APPEAL RECOMMENDATION REPORT

South Valley Area Planning Commission

Case No.: DIR-2018-322-DRB-SPP-MSP-1A
CEQA No.: ENV-2018-323-CE
Incidental Cases: None
Related Cases: DIR-2018-325-DRB-SPP-MSP-1A [withdrawn], DIR-2018-328-DRB-SPP-MSP-1A
Council No.: 4 – Ryu
Plan Area: Bel Air - Beverly Crest
Specific Plan: Mulholland Scenic Parkway Specific Plan (Outer Corridor)
Certified NC: Bel Air - Beverly Crest
GPLU: Minimum Residential; Very Low II Residential
Zone: RE15-1-H; RE40-1-H
Applicant: 2545 Bowmont, LLC
Representative: Ignacio Rodriguez
Appellant: Bennett Silverman and Joyce Silverman

PROJECT LOCATION: 2545 Bowmont Drive (Lot 2)

EXHIBIT A: Approved Grading Plan

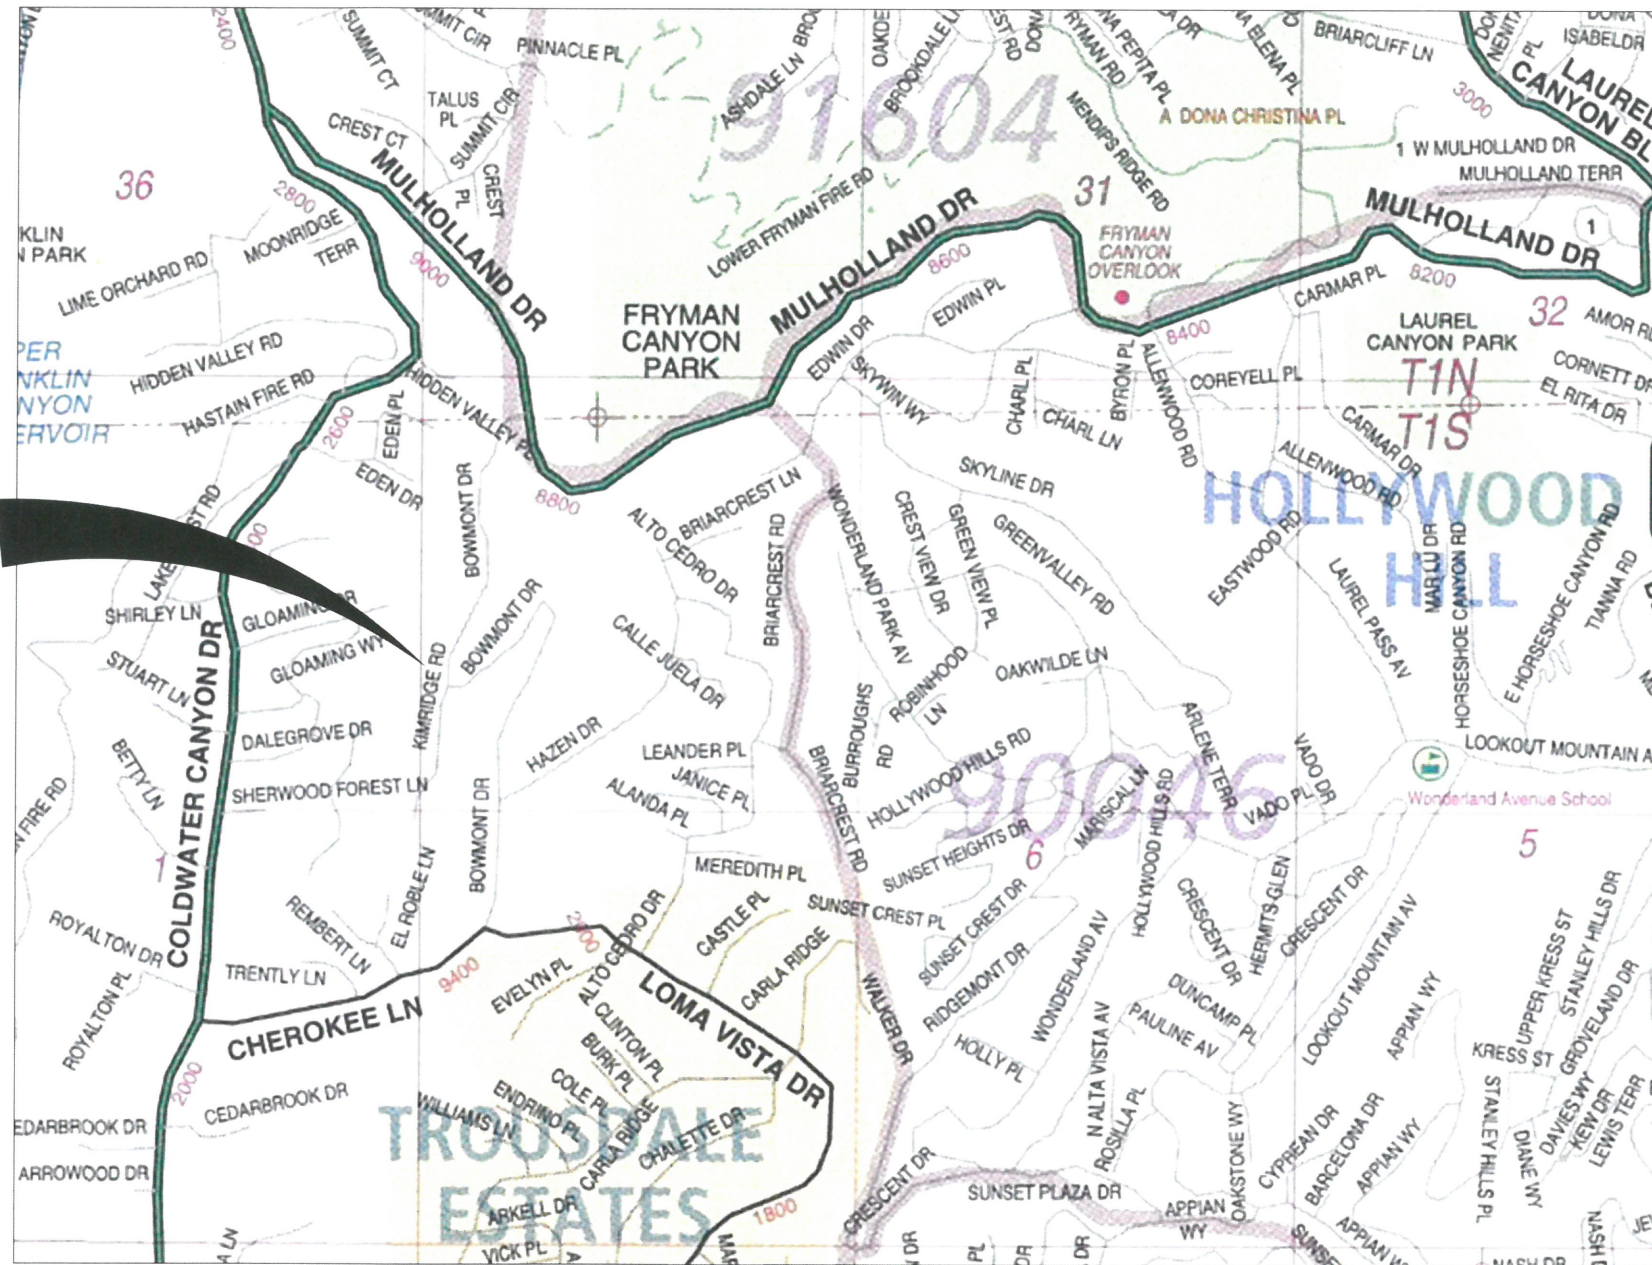
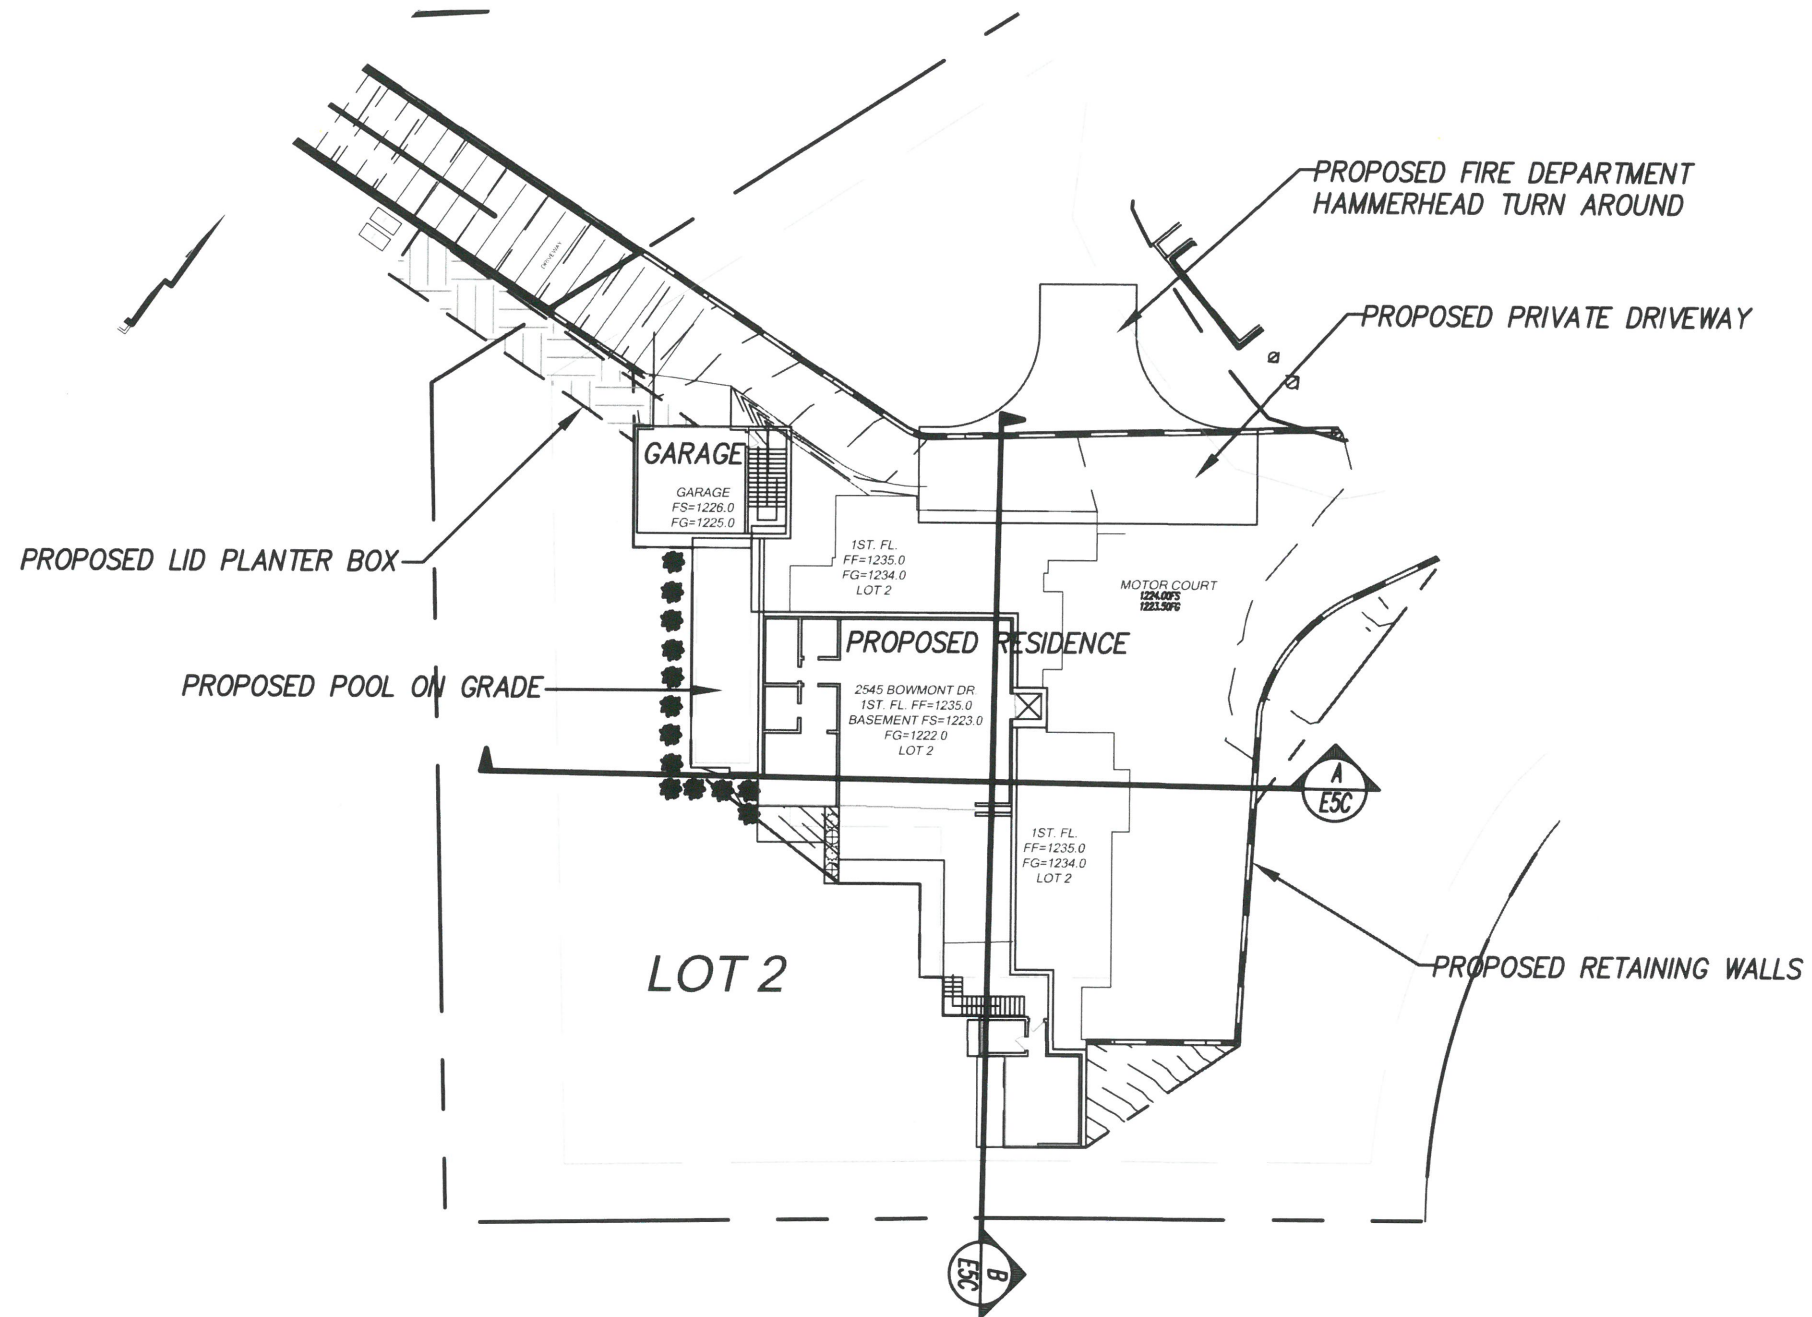
The finding is in error and cannot be supported by the submitted plans. Quantities submitted by the Applicant substantially understate the quantities of soil export. The plans provided to the MDRB and to the public are too small, lack sufficient specifics, and much of the topographical information is unreadable such that it was not possible for

According to City regulations, quantities of soil exports from adjacent lots owned and developed by the same owner, as in this case, must be counted cumulatively in assessing the need for a haul route to avoid piecemealing. The soil export quantities of the three adjacent lots, owned by one developer, could not be confirmed to fall below the 1000 cubic yard threshold because the data is not sufficient. Consequently, we believe that the development of these three contiguous lots should trigger a haul route and should not simply be approved by Planning.

Staff Response: The project requires 1,227 cubic yards to be cut, 1,176 of which will be used for fill, and 50 cubic yards will be exported; zero cubic yards will be imported. In Section 6.C, the Plan states that, “no grading in excess of two cubic yards per four square feet of lot area per lot visible from Mulholland Drive shall be permitted without the prior written approval of the Director pursuant to Section 11.” Per this Section, the applicant would be limited to 61,876 cubic yards of grading for the 123,752 square-foot lot. The proposed grading is less than the limitation imposed by the Plan and complies with applicable section(s) of the Specific Plan.

The applicant has provided a Grading Plan (EXHIBIT “F”) indicating the appropriate cut, fill, export, and import grading quantities for the proposed project. These plans were drafted, stamped, and signed by a registered civil engineer. In order to trigger a haul route, export grading quantities must exceed 1,000 cubic yards per Section 91.7006.7.5 of the LAMC. The proposed export grading quantities for this project do not exceed the threshold to require a haul route.
